PITTSFIELD ER BRF 022-1(23)
CONTRACTOR FABRICATED PRE-CAST

- SHEET1: ABUTMENT #1 PLAN
- SHEET2: ABUTMENT #2 PLAN
- SHEET3: WING WALL PLAN
- SHEET4: ABUTMENT CASTING PLAN
- SHEET5: GENERAL NOTES
- SHEET6: QC PROCEDURES/PLAN
- SHEET7: POST TENSIONING DETAILS
- SHEET8: POST TENSIONING DETAILS
- SHEET9: CONCRETE MIX DESIGN

Vermont Agency of Transportation
RECEIVED
CK'D BY JG OK'D BY WL
March 17, 2014
RESUBMIT YES Rejected
BY KH DATE 4-1-2014

ABUTMENT TYPICAL
SCALE: 1/2" = 1'-0"

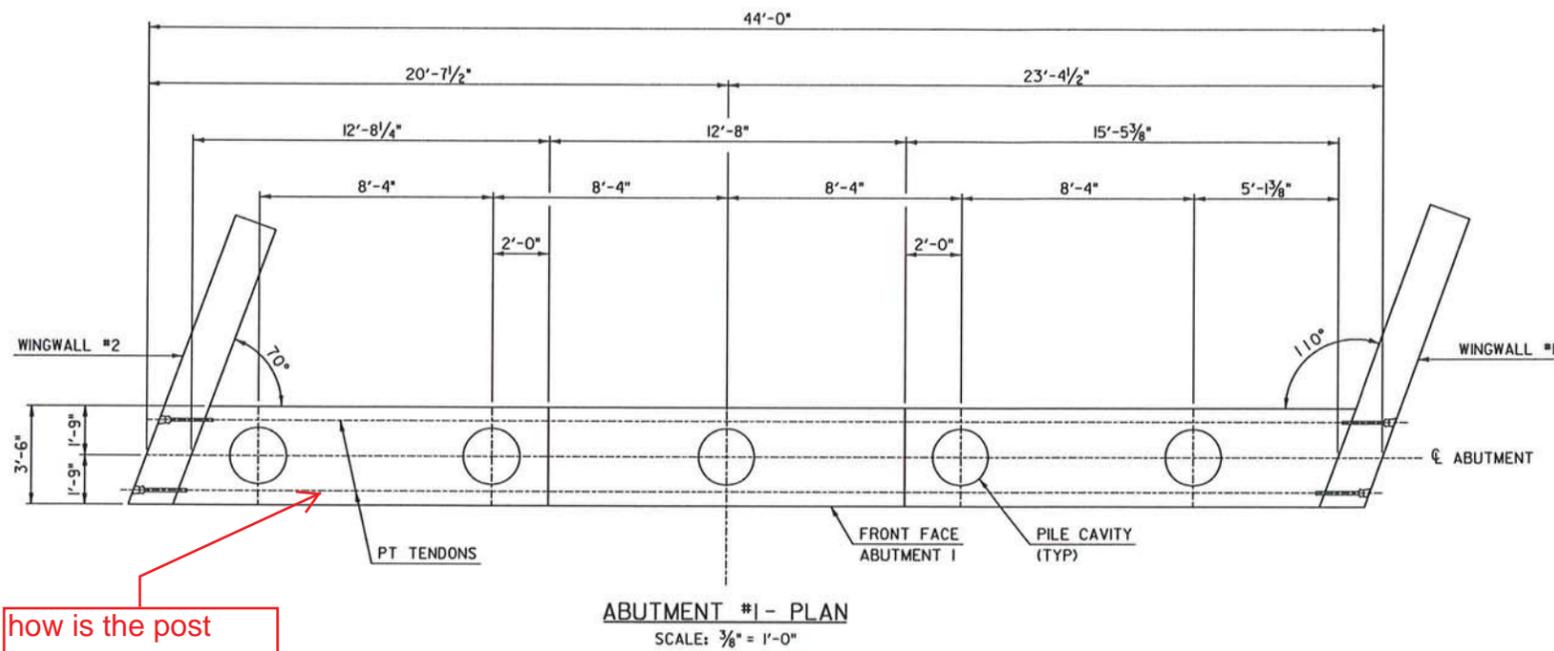
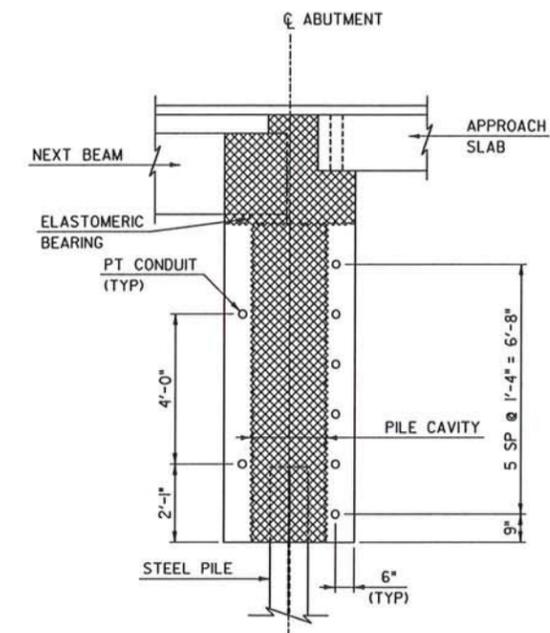
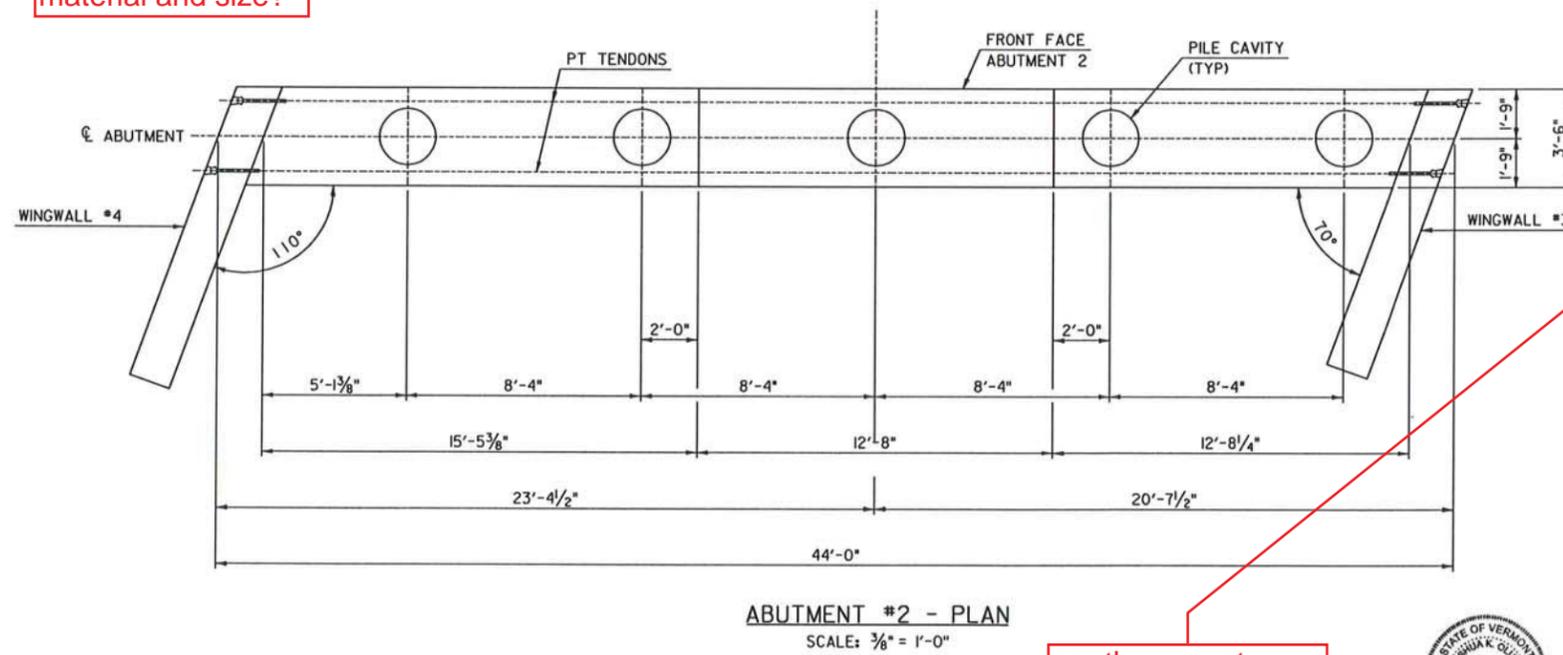
how is the post tension space being made? what material and size?

are these post tensioning ducts grouted after? if so is it stated somewhere or just understood to be?

is there a minimum strength needed for the concrete filling the pile cavities prior to final post tensioning?

This does not match the criteria stated in Note 19.

Yes, but TYLin redesigned the post-tensioning.

TYLIN INTERNATIONAL	PROJECT NAME: PITTSFIELD	PLOT DATE: 3/3/2014
	PROJECT NUMBER: ER BRF 022-1(23)	DRAWN BY: S. MORGAN
	FILE NAME: z86e060bdrabutdet.dgn	CHECKED BY: J. OLUND
	PROJECT LEADER: J. OLUND	
	DESIGNED BY: T. POULIN	
	WINGWALL DETAILS

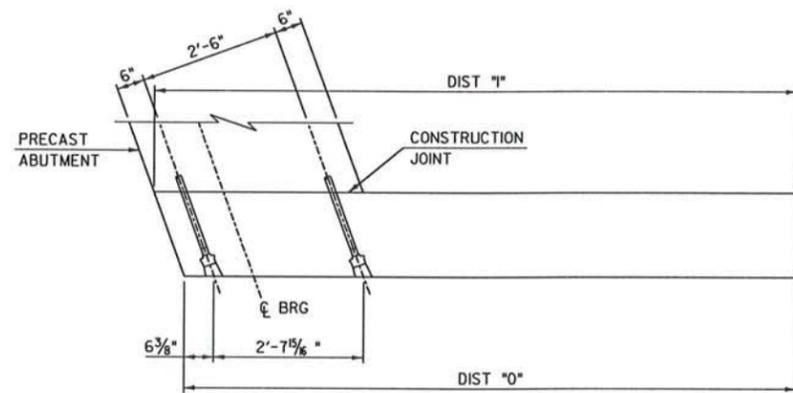
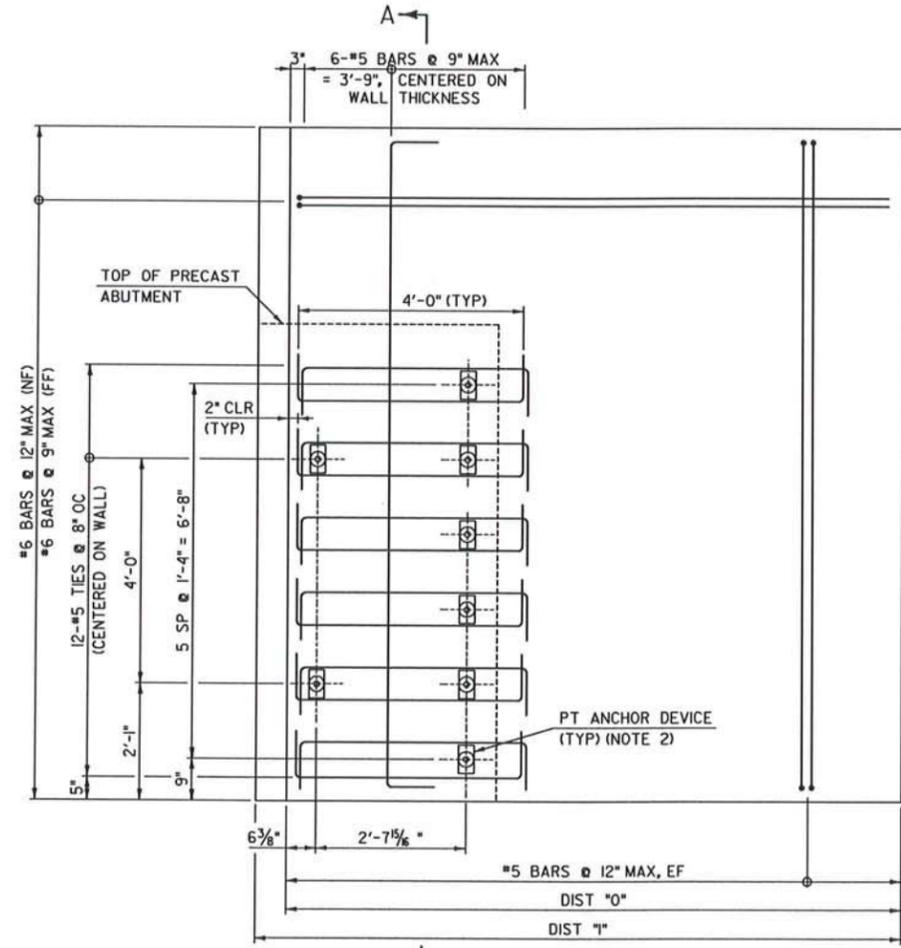
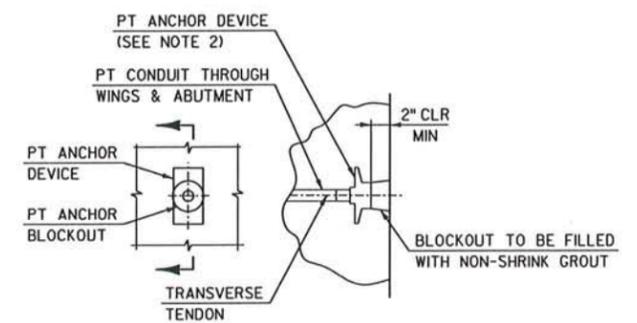
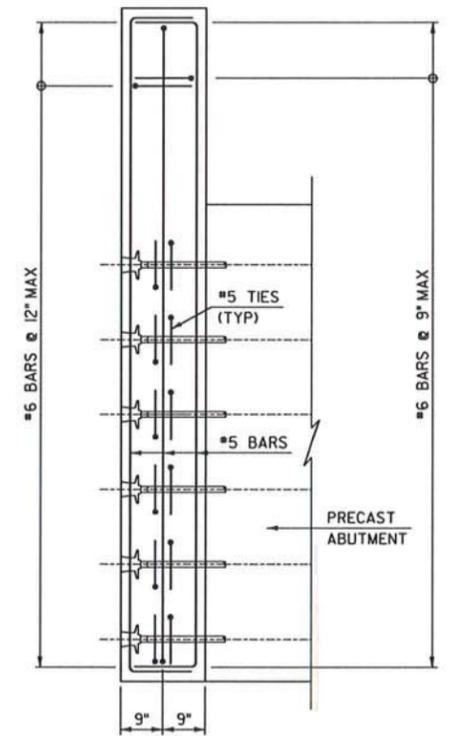
Please detail post tensioning sleeves and blockouts. TY Lin Plans do not show full dimensions, sleeve size, or materials

Galvanized per note 18.

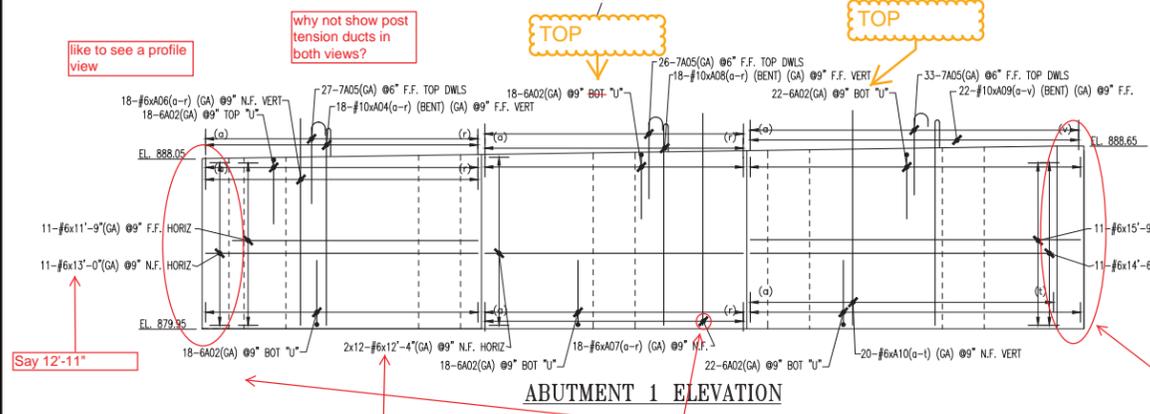
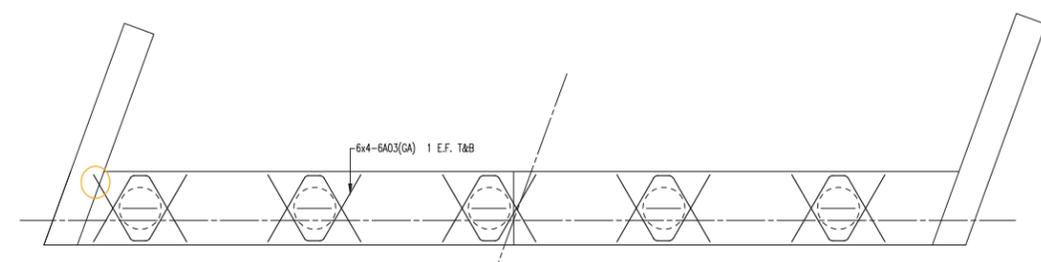
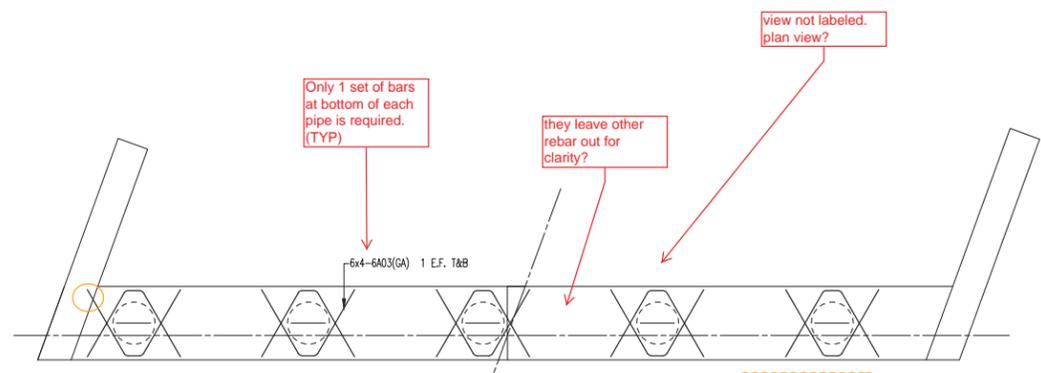
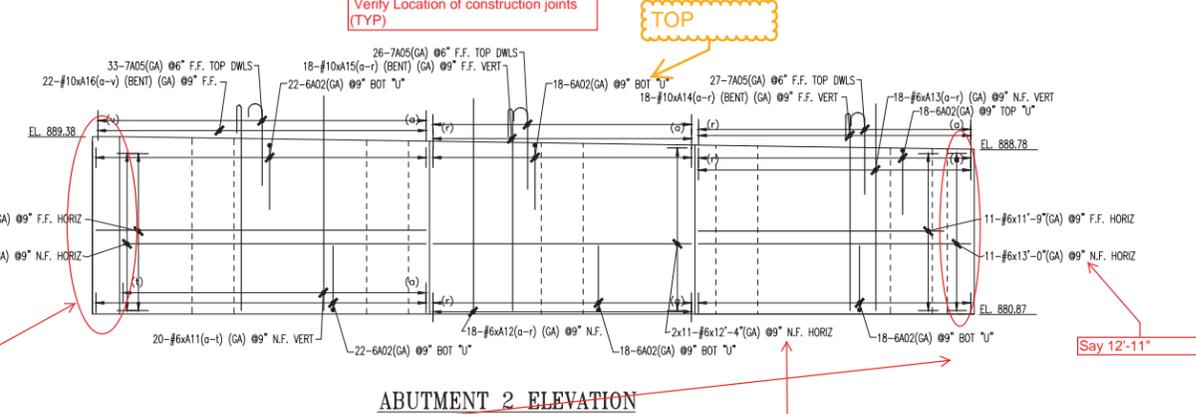
How is the reinforcing being placed on the skew between the last Pile Cavity and the edge of the stem?

How does the contractor plan on placing the reinforcing around the NEXT Beam Steams?

Bridge Seat Elevations are flat where the original cheek walls are

What about F.F.?

not familiar with that symbol

F.F bars?

Bars where the cheekwalls from the original plans were will need to be extended to the top of the cheekwall.

Grade and ASTM spec?

Verify Dimension "C" of 6A02

Verify Dimensions "A" and "J" of 7A05
